Attorney Docket No: 40124/05301 (I 7549/KK)

REMARKS

Appl. No. 10/544,269

Reply to Office Action of Dec. 26, 2007

Fig. 1

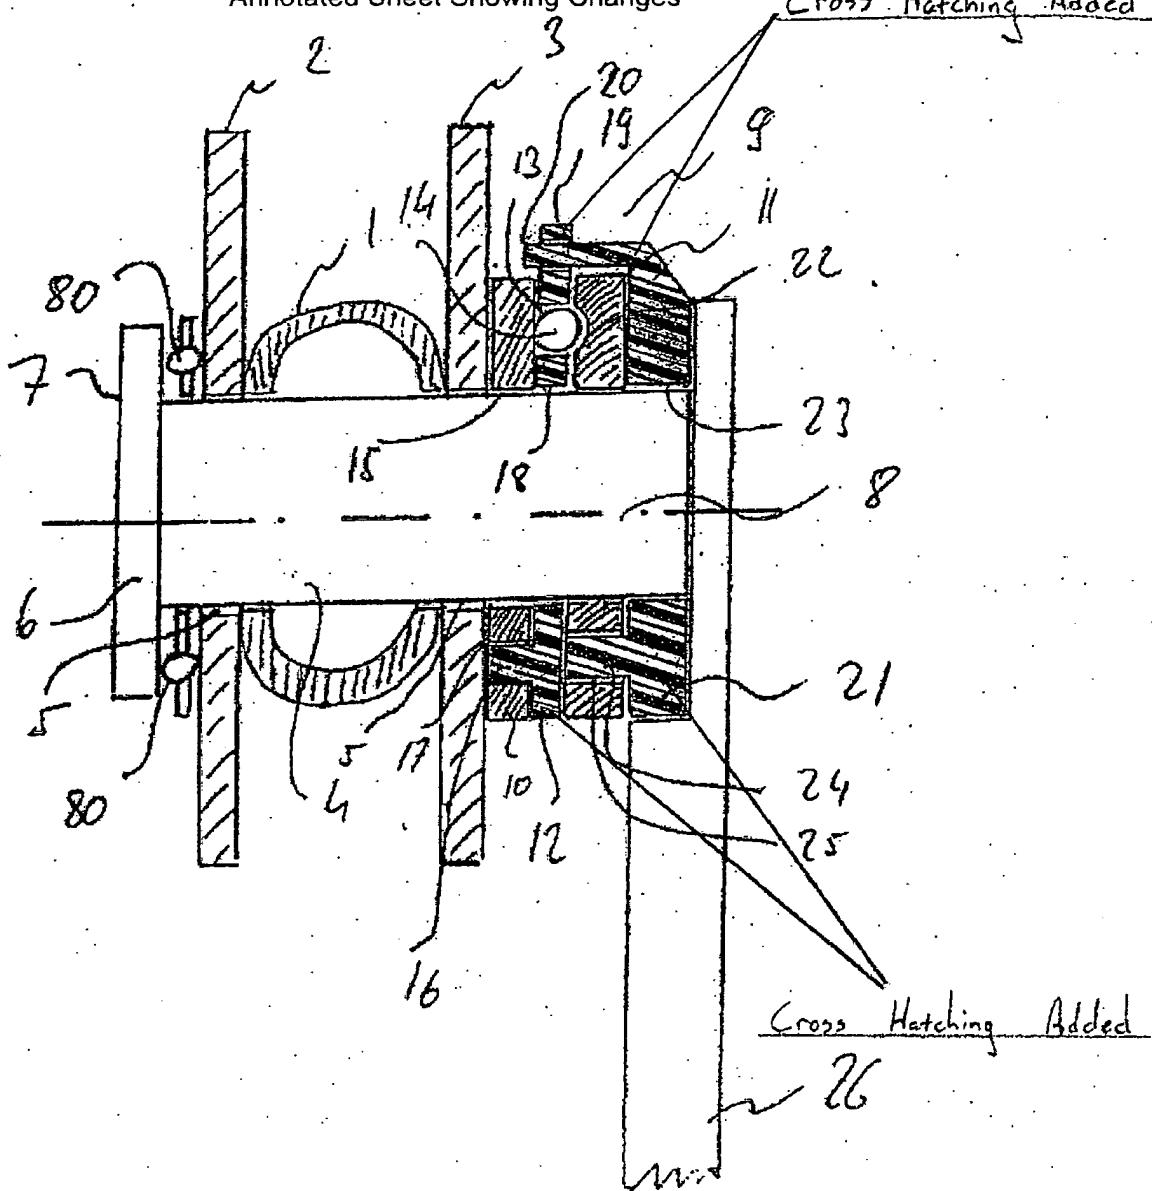
The Examiner has objected to the drawings on the grounds that "the cross hatching for the guide element and the lever adapter should correspond to the symbol for plastic as required by 37 CFR 1.84(n)." (See 12/26/07 Office Action, p. 2.) Applicants have submitted corrected drawing sheets in compliance with 37 CFR 1.12(d). As the Examiner will ascertain, the drawings have been amended to incorporate a distinct cross hatching to indicate that the "guide element" and "lever adapter" portions of the device are composed of plastic. The cross hatching pattern chosen is one that employs a distinct "thin-line, thick-line" pattern. Thus, Applicants respectfully submit that the objection to the drawings should be withdrawn.

Applicants have submitted replacement drawings for figures 1 and 4. (See Attached "Replacement Sheets", Fig. 1; Fig. 4.) Applicants have also provided annotated drawings, showing the changes made from the prior drawings. (See Attached "Annotated Marked-Up Drawings", Fig. 1; Fig. 4.)
